PINEVIEW HEIGHTS, RESUBDIVISION OF LOTS 27 -33

FINAL PLAT COMMENTS (should be addressed prior to submitting the FINAL PLAT for review and/or signature by the City Engineer):

APPLICATION NUMBER 8 DATE July 18, 2019
 APPLICANT Pineview Heights Subdivision, Resubdivision of Lots 27-33
 REQUEST Subdivision

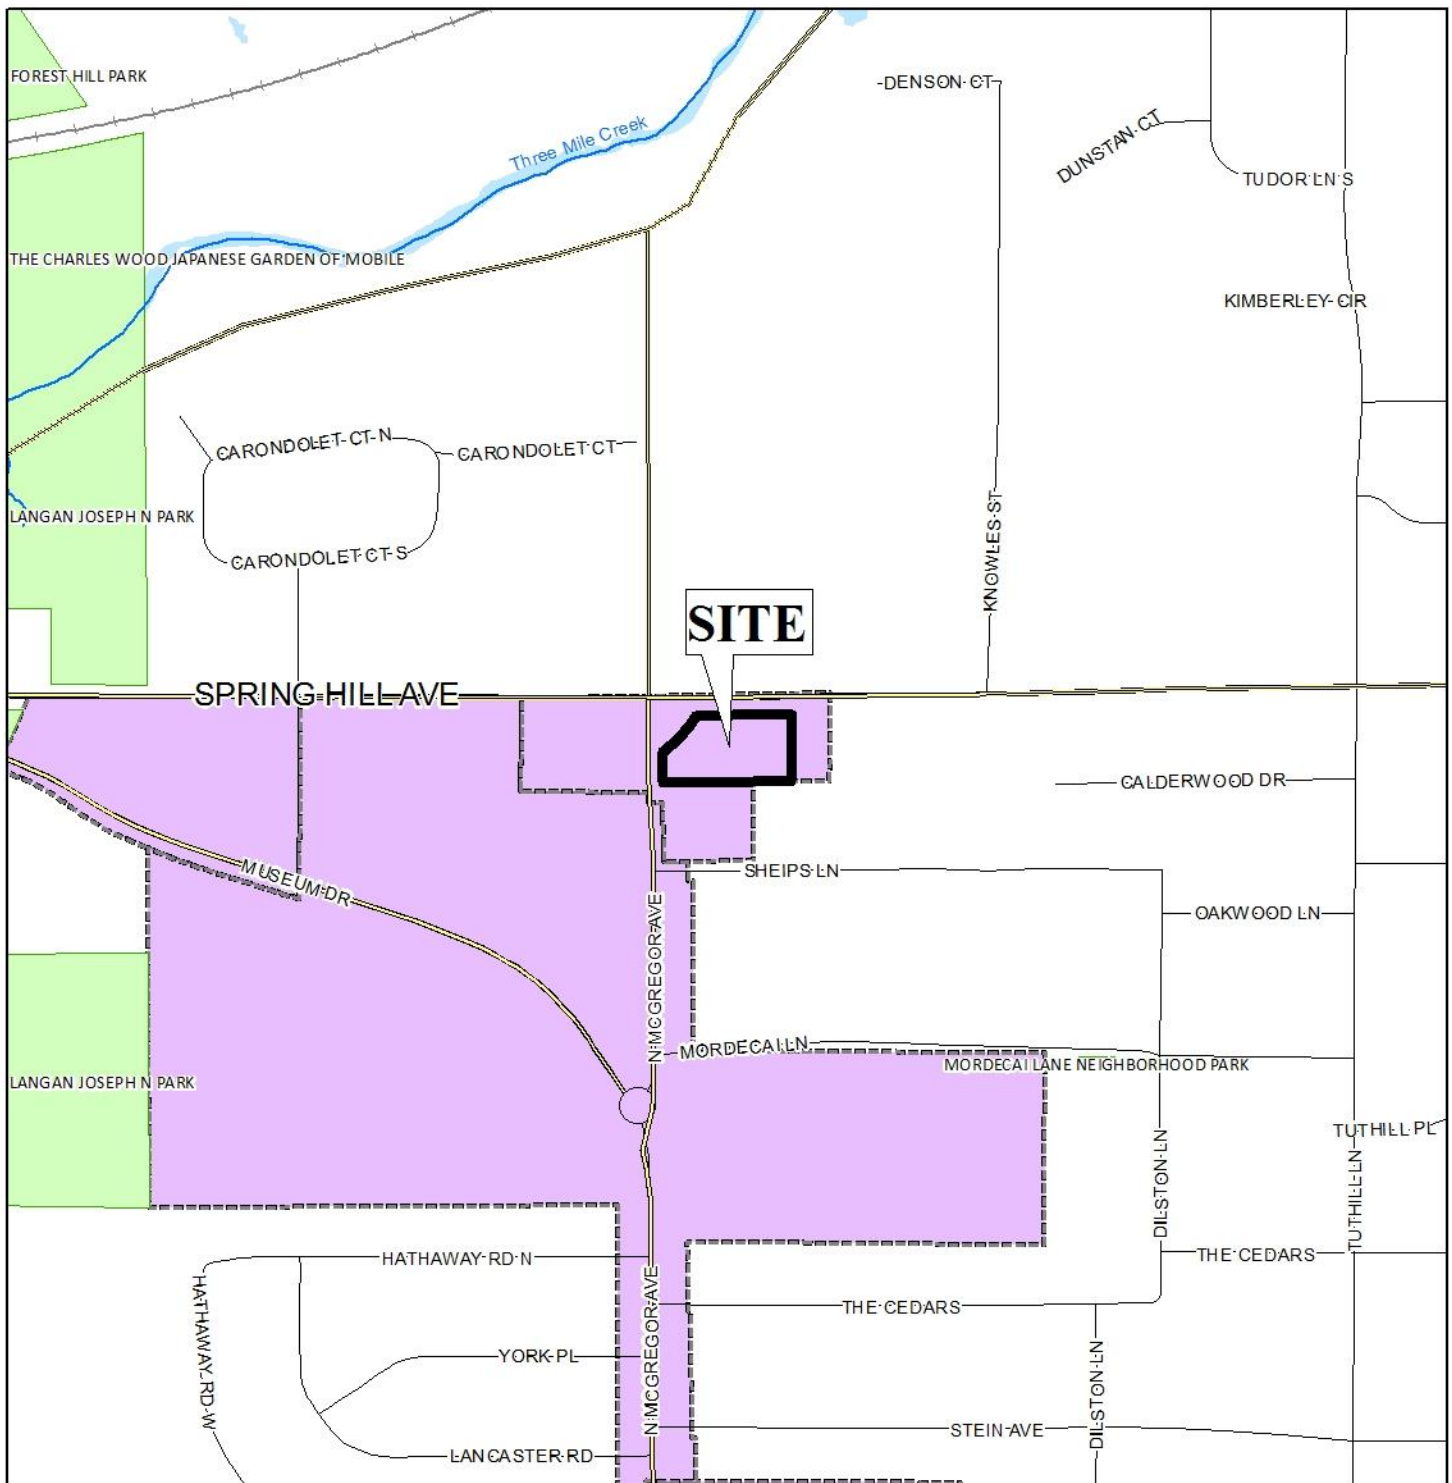
The proposed lot fronts Spring Hill Avenue and North McGregor Avenue. Spring Hill Avenue is a Major Street requiring a 100' right-of-way width. The right-of-way width for Spring Hill Avenue has not been provided. If approved, the Final Plat should be revised to either provide 50' from the centerline of Spring Hill Avenue or illustrate sufficient existing right-of-way. North McGregor Avenue is a minor street requiring a 60' right-of-way width. The right-of-way width has not been provided. If approved, the Final Plat should be revised to either provide 30' from the centerline of North McGregor Avenue or illustrate sufficient existing right-of-way.

A 25-foot minimum building setback is required for both street frontages; however, minimum building setbacks are not illustrated on the preliminary plat. The Final plat should be revised to provide a 25' minimum building setback along both street frontages, from any necessary dedication, if approved.

The proposed Lot 1 exceeds the 7,200 square foot minimum lot size requirement for lots served by public water and sanitary sewer systems. The preliminary plat provides the lot sizes in square feet and acres. If approved, the lot size information should be retained on the Final Plat.

As a means of access management, a note containing the Traffic Engineering comments should be placed on the Final Plat.

- 1) Provision of 50' from the centerline of Spring Hill Avenue or revision of the Final Plat to depict sufficient existing right-of-way;
- 2) Provision of 30' from the centerline North McGregor Avenue or revision of the Final Plat to depict sufficient existing right-of-way;

- 3) Provision of a 25' minimum building setback line along both street frontages, from any required dedication;
- 4) Retention of lot size information in both square feet and acres;
